Updates from v4.4
- Removed Teensy 4.1 and replaced with ESP32 Devkit V1
- Added Shifting SD reader
- PCB dimensions changed to 30 by 118.4 from 24.3 by 118.4.

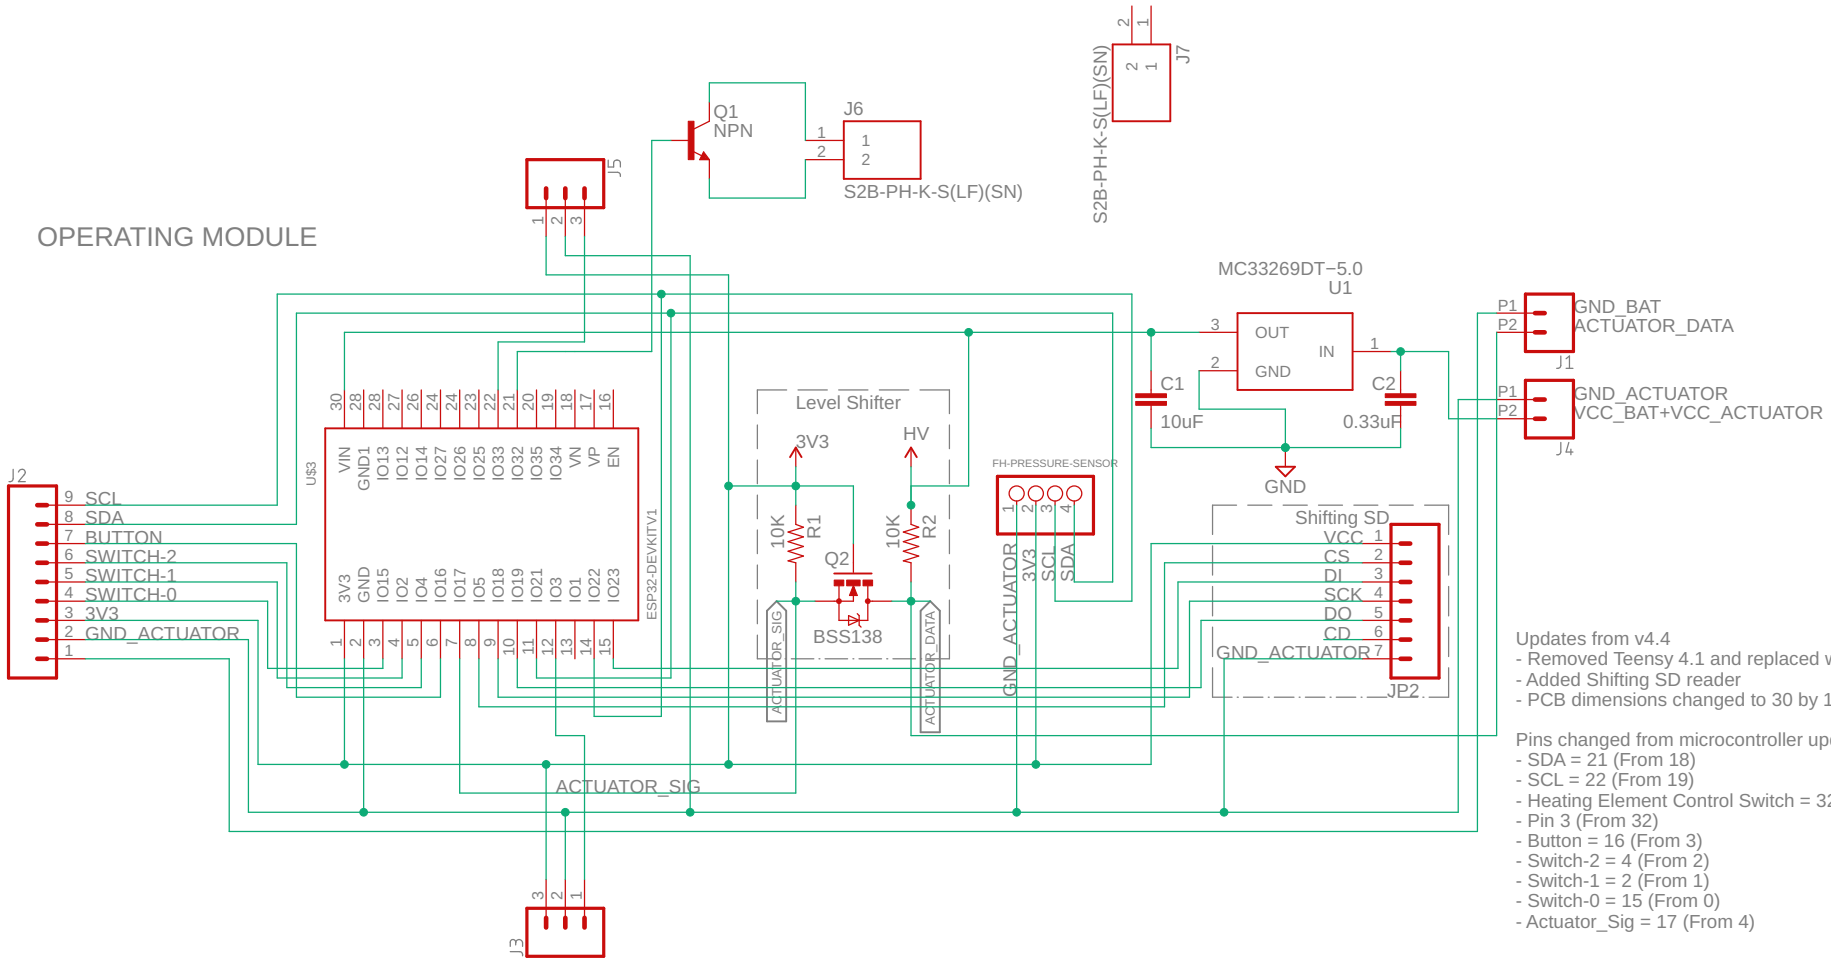
Pins changed from microcontroller update:
- SDA = 21 (From 18)
- SCL = 22 (From 19)
- Heating Element Control Switch = 32 (From 34)
- Pin 3 (From 32)
- Button = 16 (From 3)
- Switch-2 = 4 (From 2)
- Switch-1 = 2 (From 1)
- Switch-0 = 15 (From 0)
- Actuator_Sig = 17 (From 4)
